Response to Submissions and Amendment Report

21, 23 & 25 McIntosh Street and 55 Werona Avenue, Gordon

Submitted to Department of Planning, Housing and Infrastructure
on behalf of CPDM Pty Ltd

12 May 2026

Figure 8 Proposed new Level 8 units (Source: PMDL Architects)

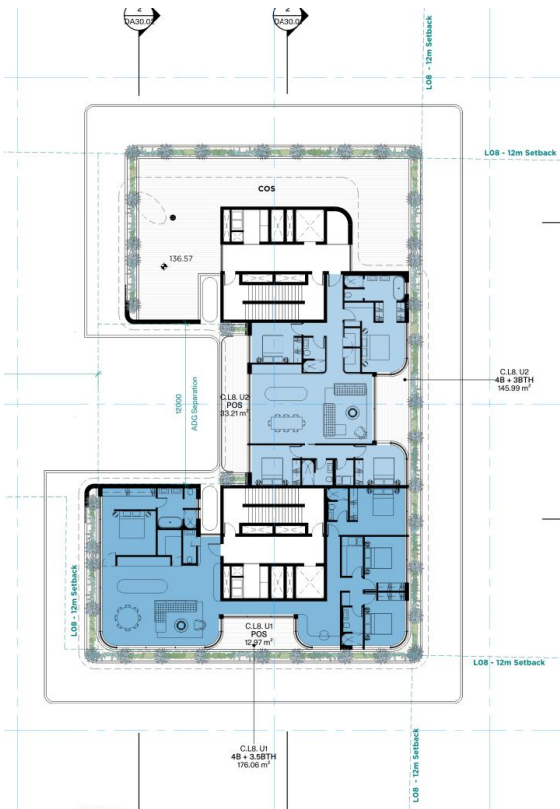
Two new units four-bedroom units and a new communal open space is now proposed within Building C on Level 8 (9th storey).

Figure 9 Communal open space on level 4 of Buildings A/B (Source: PMDL)

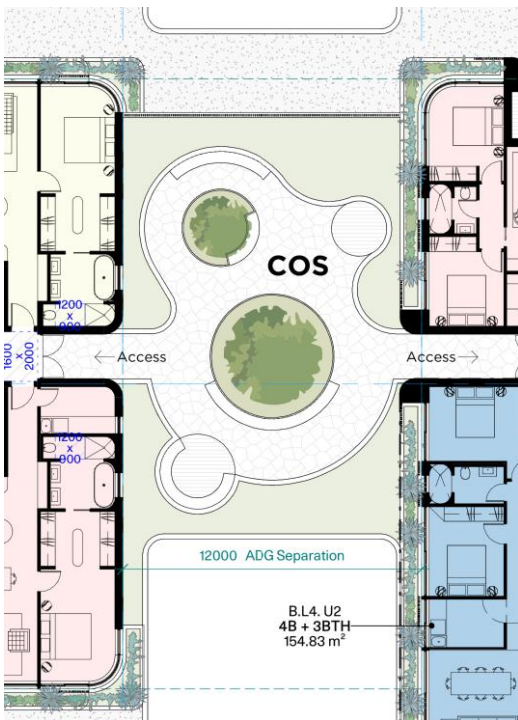
The area between Buildings A and B has been infilled up to Level 4 to accommodate additional units, comprising seven 3-bedroom dwellings, with additional communal open space provided at the roof level (refer to **Figure 9**).

Figure 10 Previously proposed Basement 2 (Source: PMDL Architects)

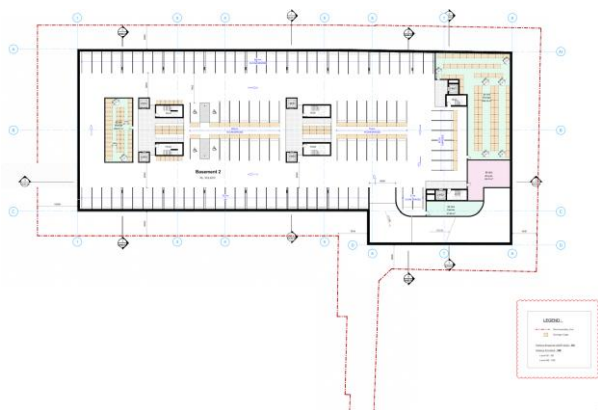
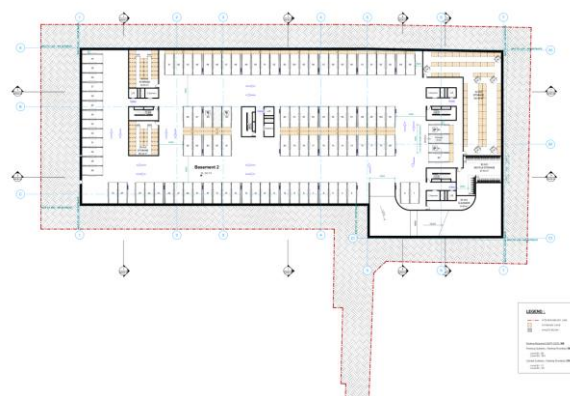
The basement layout has been reconfigured to accommodate changes to lift locations and the unit mix with additional 4-bedroom units and less 1- and 2-bedroom units. The car parking spaces on this level have been increased from 100 spaces to 101 spaces.

Figure 12 Previously proposed Basement 1 (Source: PMDL Architects)

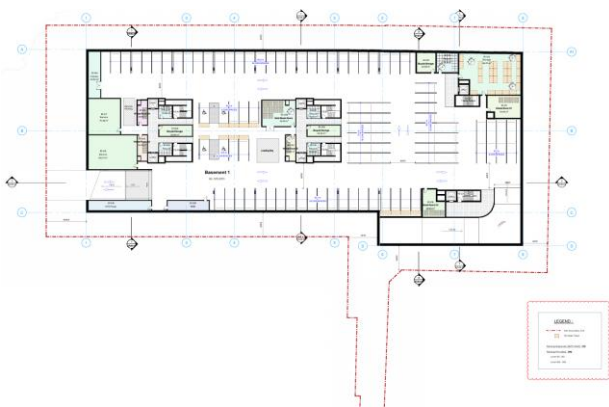
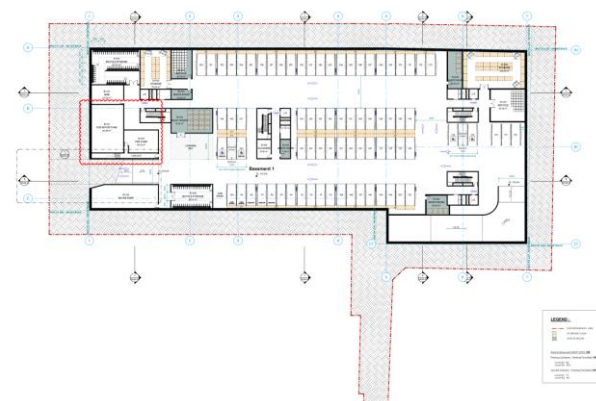
The basement layout has been reconfigured to accommodate changes to lift locations and the unit mix. The car parking spaces on this level have been decreased from 90 spaces to 77 spaces.

Figure 36 View A previously proposed (Source: Modata)

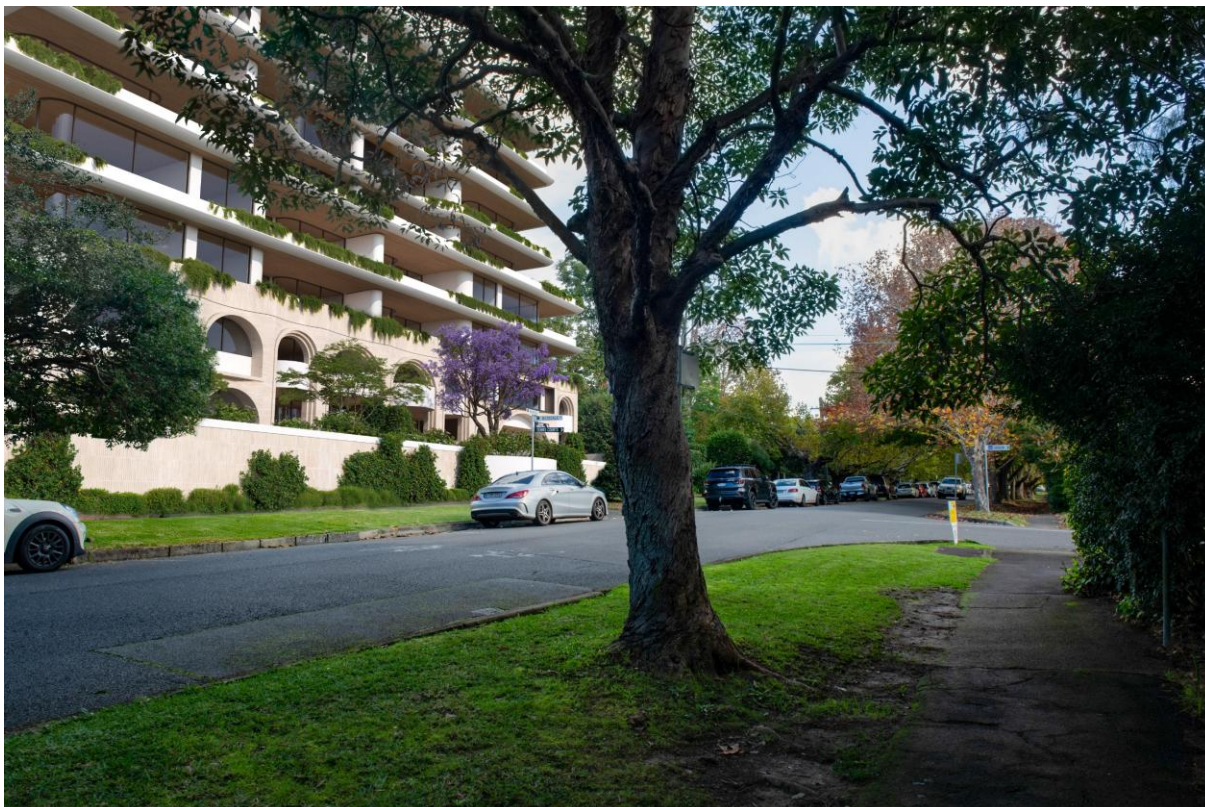
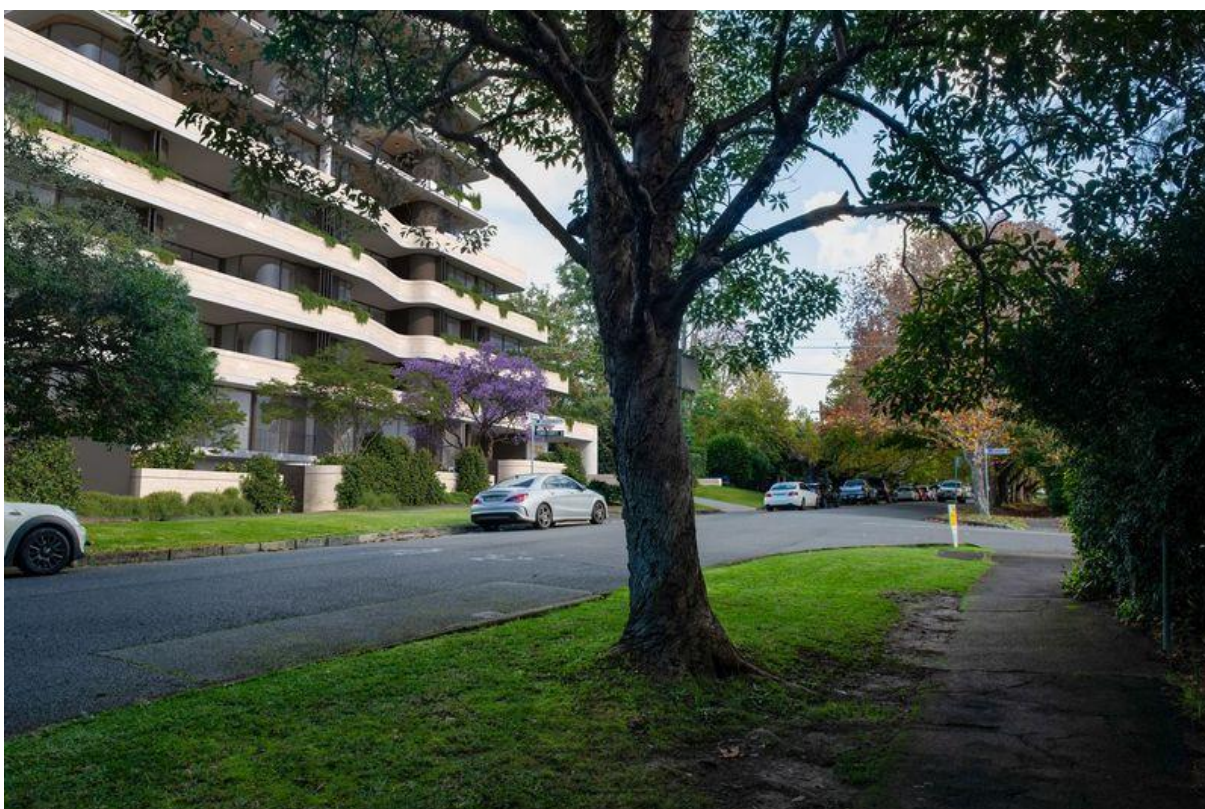
The amended design replaces the arched components on the building's lower levels with wide horizontal bands to promote a more cohesive front façade expression which is sympathetic to the streetscape setting.

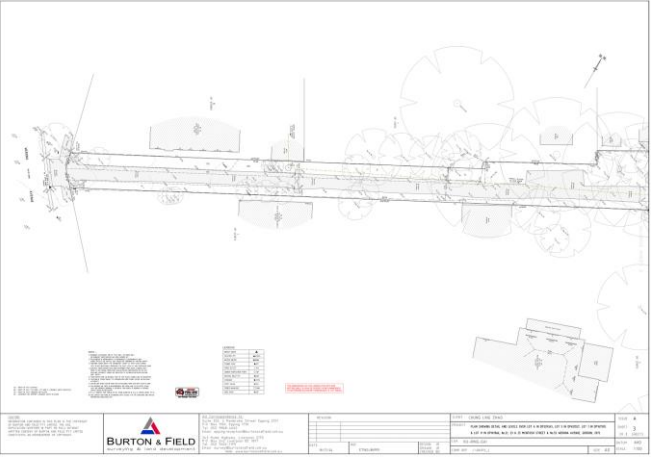
21	Ensure all bedrooms within apartment AG.06 include a window.	See amended Architectural Plans at Appendix H .
22	Provide additional information/DP plan of 55 Werona Avenue clearly showing the location and type of all easements burdening and/or benefiting the site.	The DP plan of 55 Werona Avenue was provided as part of the Survey Plan for the original application which correctly identifies all the types of easements burdening and/or benefiting the site (Screenshot shown

Item	RFI Comment	Project Response
		<p>below). Also see Appendix Z.</p>  <p>Figure 55 Werona Avenue access handle survey plan (Source: Burton & Field)</p> <p>There is a parcel of land that is known as Lot 11 DP752031, there are no works proposed in this location (See Figure 56 below).</p>  <p>Figure 56 Part lot 424 – Werona Avenue (Source: SIX Maps)</p>
